**SCAP REFERRAL – Regulation 23 (2) (b) - COUNCIL COMMENTS
DA 22043006 – 163a-164 Greenhill Road Parkside**

Mixed use (commercial and residential) development comprising eleven (11) levels (western building) and nine (9) levels (eastern building), as well as adaptive reuse and extension of an existing Local Heritage Place, accommodating a commercial tenancy, 233 residential apartments together with associated shared amenities, swimming pool, carparking and landscaping

Greenhill Road Elevation

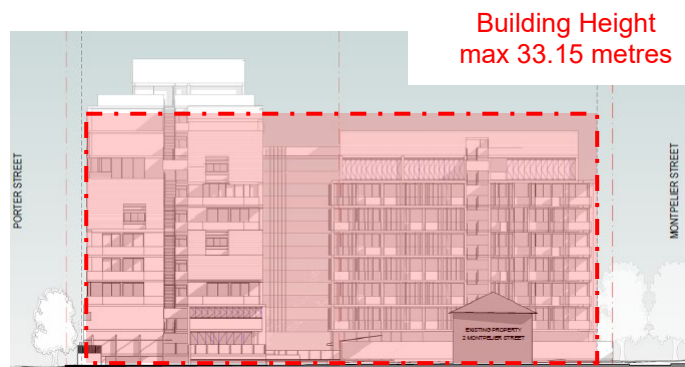
- Western tower building indicated to be 35.1 metres (34.8 plus 0.3 above ground level) to front facade and terrace fence (extra 1.65 metres or 5%) but up to 39.9 metres to terrace roof top (extra 6.75 metres or 20%) over an already arbitrary 30% bonus increased height;

Building Height
max 33.15 metres

Rear South Elevation

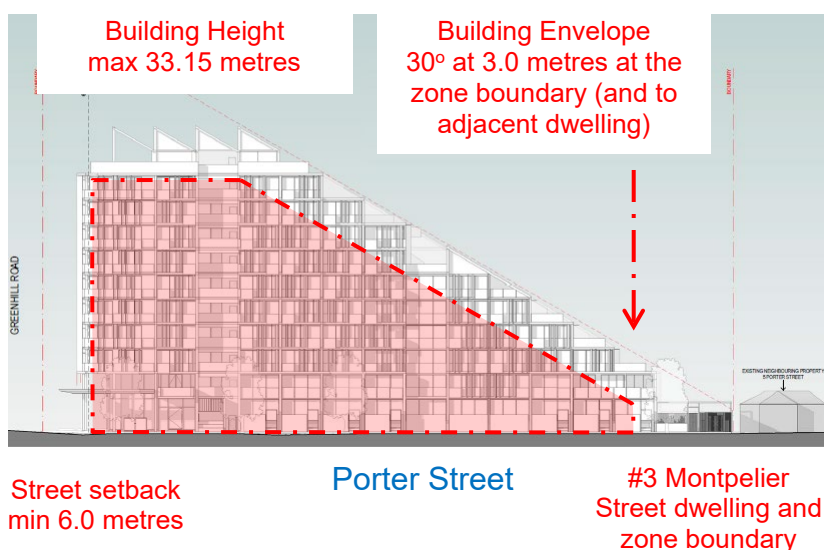
- The more critical intrusion is in relation to the Building Interface Envelope (30 degrees at 3m agl). The envelope should be from the zone boundary (adjoining residential use in an adjacent low rise Neighbourhood Zone), which was carefully and consciously aligned upon introduction of the new Corridor Zone, to provide a proper and orderly demarcation between diverse scales of development, limit overbearing building mass and overshadowing;

- The interface policy and desired intent has been undermined, with inclusion of the adjoining dwelling property beyond the zone boundary, creating intrusion into Porter Street with substantially more building mass and visual impact, and exacerbating overshadowing, to the adjoining low-rise Neighbourhood Zone;
